Access Compliance Report

Public Rights-of-Way

(Curb Ramps)

Intersection ID: 7812	Main Street: SQUIRREL_HILL_RD	Cross Street: THORNWOOD_RD	Location: E
ADA ID: 41B3E4AAC9C7	Ramp Type: PerpDiag	Initial Pass/Fail: Fail	Overall Compliance: No
		Severity Score: 10

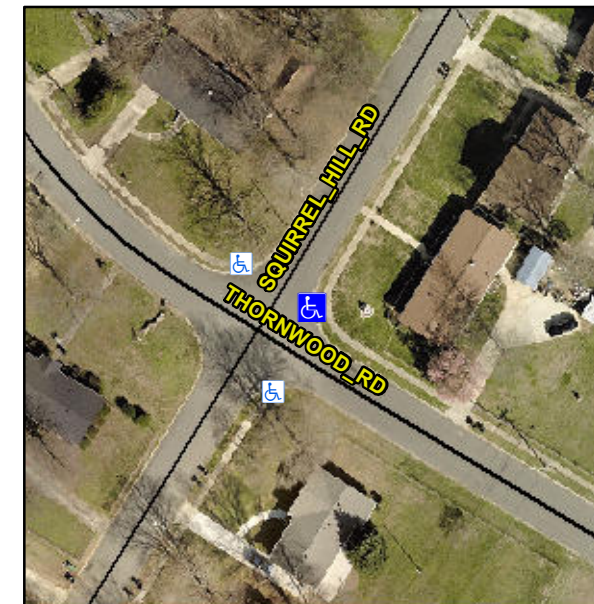
Not Found, R304.5.1, R304.5.3

Compliance	Description	Data	Compliance	Description	Data
N/A	Ramp Length (in)	45.5	Yes	Ramp Slope (%)	7.4
No	Ramp Width (in)	47.5	No	Ramp XSlope (%)	4.3
N/A	Flare Type LT	N/A	N/A	Flare Type RT	N/A
N/A	Flare Slope LT (%)	N/A	N/A	Flare Slope RT (%)	N/A
N/A	Flare Traversable LT?	N/A	N/A	Flare Traversable RT?	N/A
N/A	Landing Length (in)	N/A	N/A	DWS Provided?	N/A
N/A	Landing Width (in)	N/A	N/A	DWS Contrast?	N/A
N/A	Landing Slope (%)	N/A	N/A	DWS Length (in)	N/A
N/A	Landing X Slope (%)	N/A	N/A	DWS Full Width?	N/A
N/A	Landing Curb? (Y/N)	N/A	N/A	DWS Offset (in)	N/A
N/A	Shared Landing?	N/A			
N/A	Gutter Ponding?	N/A	N/A	Gutter Slope (%)	N/A
N/A	Gutter Lip Ht (in)	N/A	N/A	Gutter X Slope (%)	N/A
N/A	Painted X Walk1?	No	N/A	Painted X Walk2?	No
	X Walk 1 Direction	To NW		X Walk 2 Direction	To SW
N/A	X Walk 1 Width (in)	N/A	N/A	X Walk 2 Width (in)	N/A
	X Walk 1 Slope (%)	2.7		X Walk 2 Slope (%)	0.4
	X Walk 1 X Slope (%)	0.6		X Walk 2 X Slope (%)	1.2

Remove & Replace Curb Ramp With Two New Directional Ramps or Equivalent.
